**CALVERT CLIFFS UNIT 1
SFP CRITICALITY ANALYSIS**

DCALC No.: CA06011 Revision No.: 0

Title: UNIT 1 SPENT FUEL POOL ENRICHMENT LIMIT WITH SOLUBLE BORON CREDIT

3. REVIEWER COMMENTS

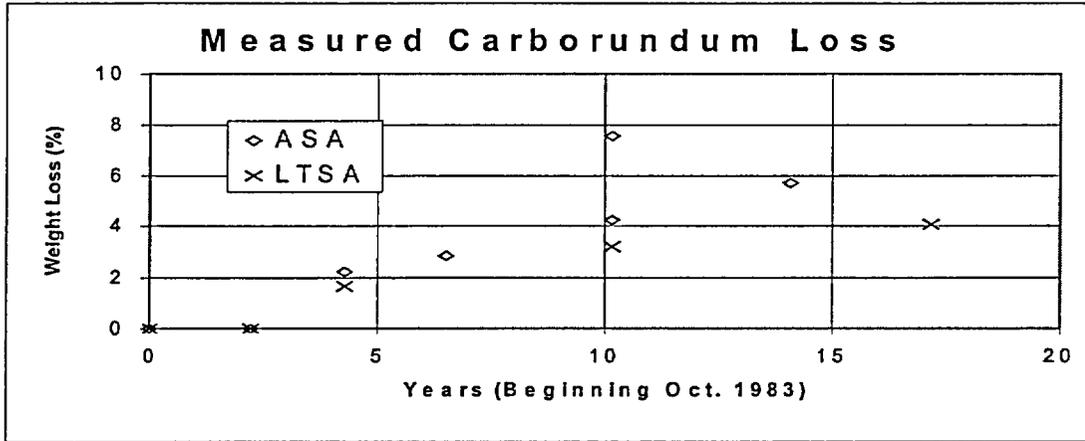
Section 9 B.7. The calculation uses a 26.2% boron loss (0.024 to 0.0177 g/cm²) over the life of the spent fuel pool racks. This is a conservative assumption based on the measured data.

ETP 86-03, "Analysis of Neutron Absorbing Material in the Spent Fuel Storage Racks," provides direction for long term surveillance of the neutron absorption material samples in both spent fuel pools' racks. The samples are in two different sample assemblies: an Accelerated Surveillance Assembly (ASA) and a Long Term Surveillance Assembly (LTSA). After each refueling, freshly discharged fuel assemblies surround the ASA samples. ETP 86-03, revision 3 contains the following measured data of carborundum loss:

Except for the obvious anonymous data, the ASA shows a very linear trend of 0.414% loss per year. Using this ASA data, this results in a conservative service life of 63 years (26.2% allowable loss + 0.414% loss per year) for the carborundum. The Unit 1 spent fuel pool racks were installed in 1983. Based on the carborundum loss, the service life of 63 years ends in 2046. This exceeds the requirement for a service until 2044. (Unit 1 license expires in 2034 plus 10 years of decommissioning).

Response OK

ATTACHMENT F
UNIT 1 SFP PLANAR GEOMETRY

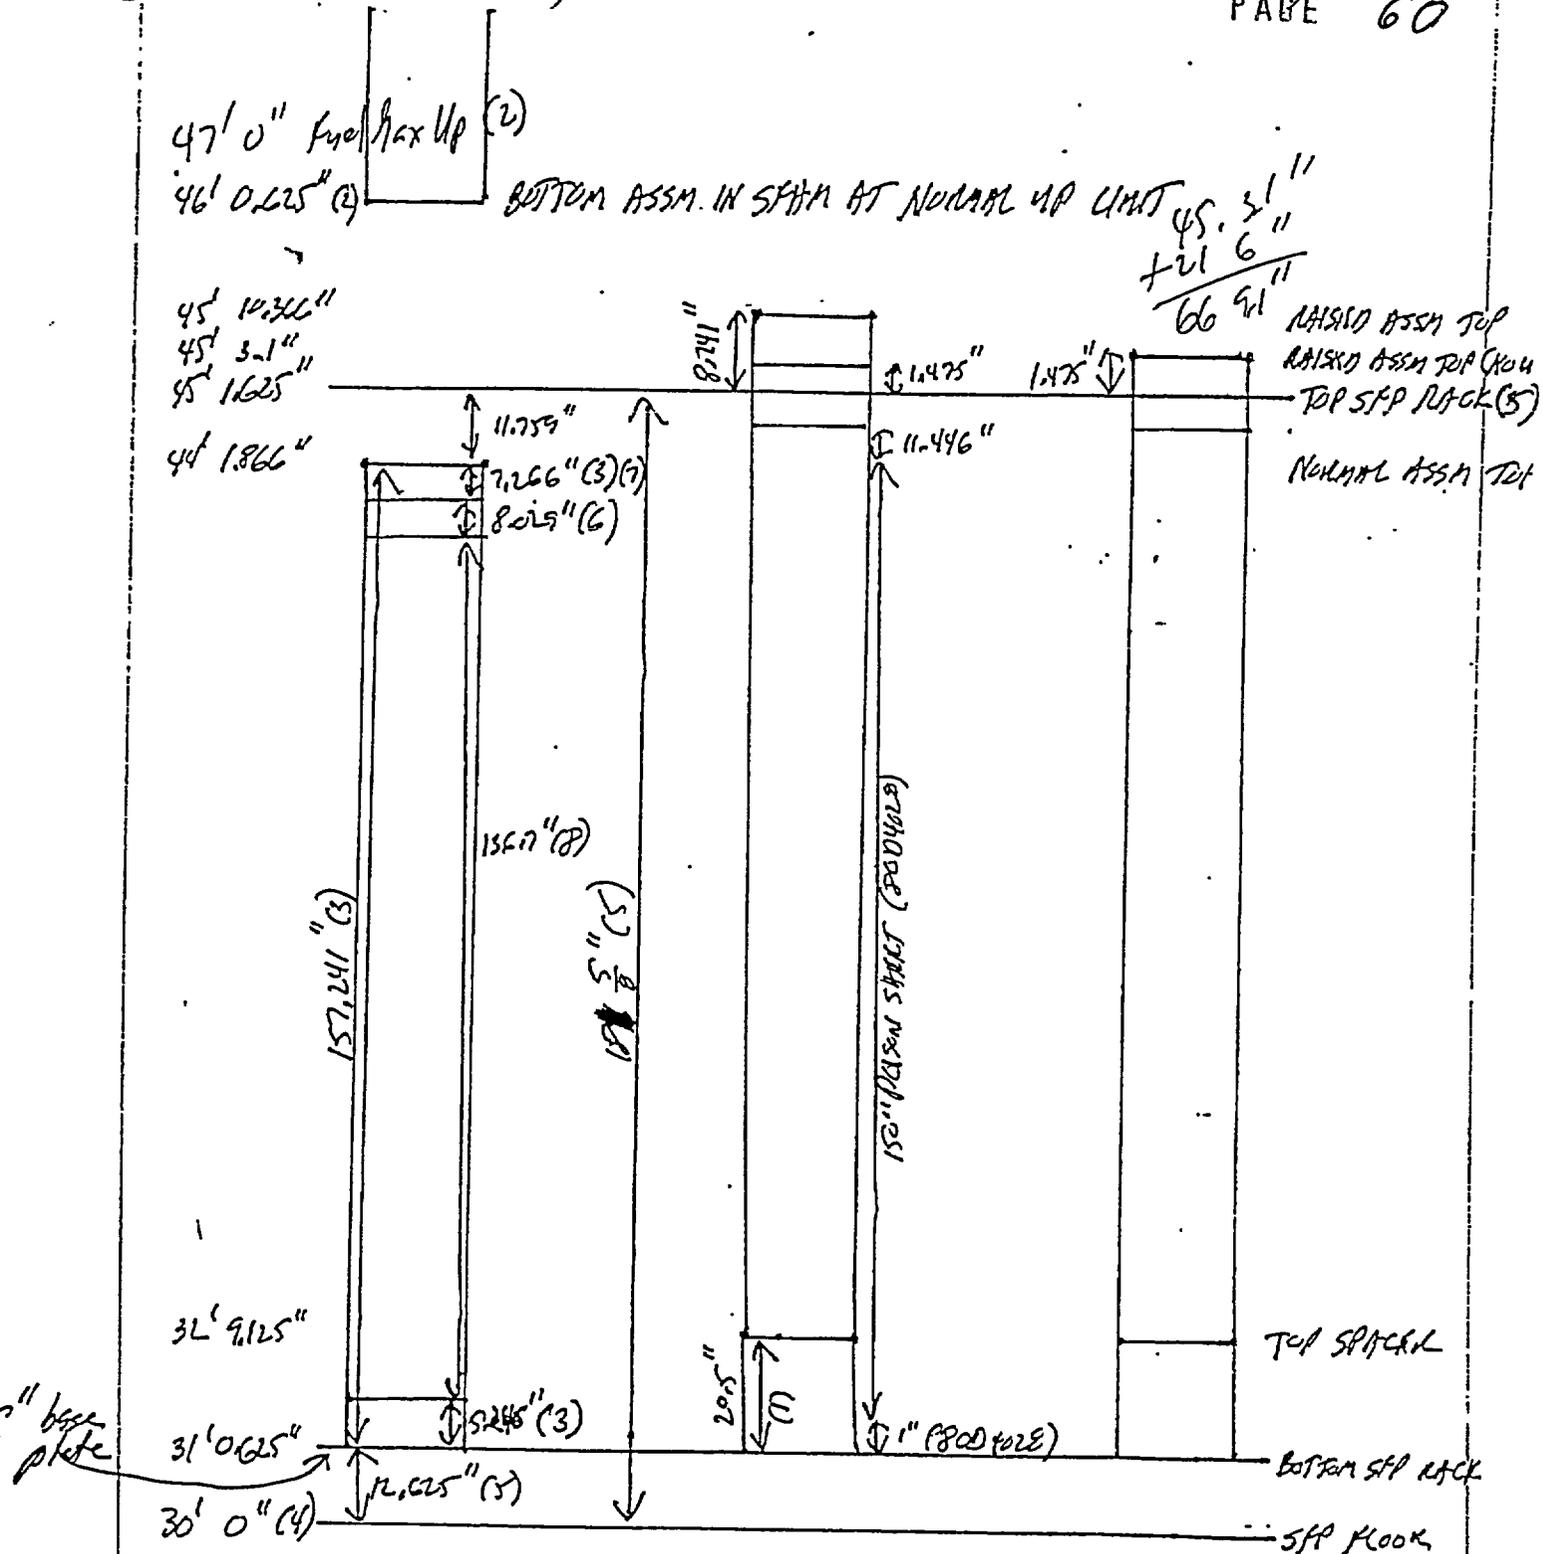
(d) Reference 23 indicates that dimension "D" is 96" rather than the 83-3/8" used in the hand-drawn figure in back The 83-3/8" appears to be the distance to the elevation change, but not the side of the pool Thus, the section represented by dimensions "F"x"L" should be water rather than concrete However, this hand-drawn figure is not entirely representative of the model since that region and the region represented by "D"x"L" is assumed to be concrete in the model.

Response: The above simplification should have no effect on the reactivity results.
